From: Habib, Donald
Sent: Thursday, May 30, 2019 1:48 PM
To: Vogle PEmails
Subject: FW: Clarification: LAR 19-004 Drawing Inconsistencies
Attachments: LAR 19-004 Differences in Drawing Symbols_ (002).docx

For LAR 19-004, the staff identified differences in the Tier 1 and Tier 2 drawings. Please contact the Project Manager for this LAR, Peter Hearn, about whether SNC would like to discuss this clarification question in a future public meeting.

Below are 2 examples where the valves do not match up symbolically between Tier 2 Figure 10 and Tier 1 Figure 2. For the symbol differences of the same component, please provide an explanation.

Tier 2, Figure 10.3.2-2 Main Steam System Diagram

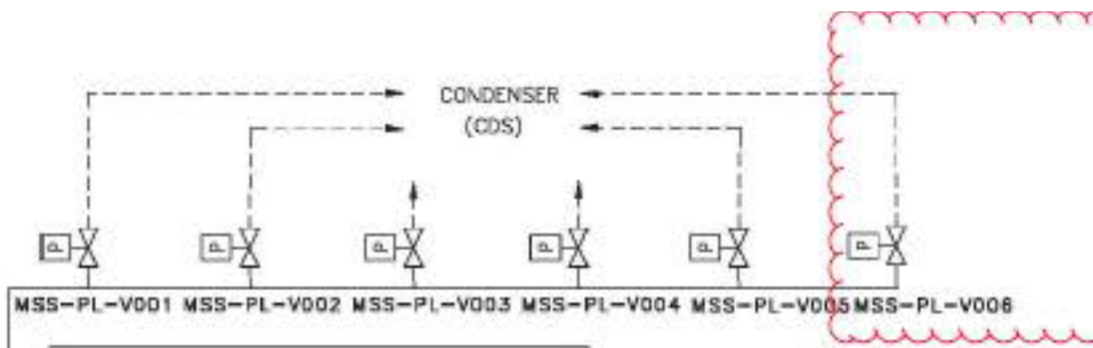
1. The valves in figure 10 below do not match the valve in figure 2 and valve shown in the Tier 2 Chapter 1 legend drawings.

Tier 2, Figure 10.3.2-1 (Sheet 2 of 2)

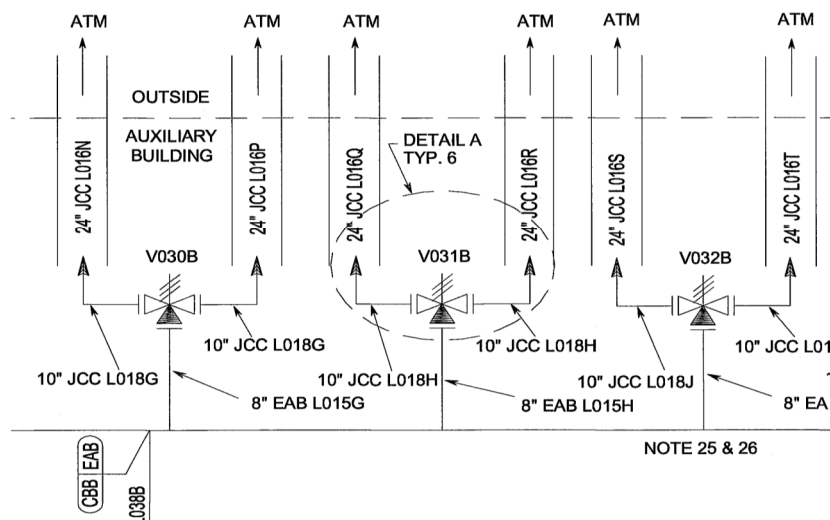
2. The relief valves below do not match the
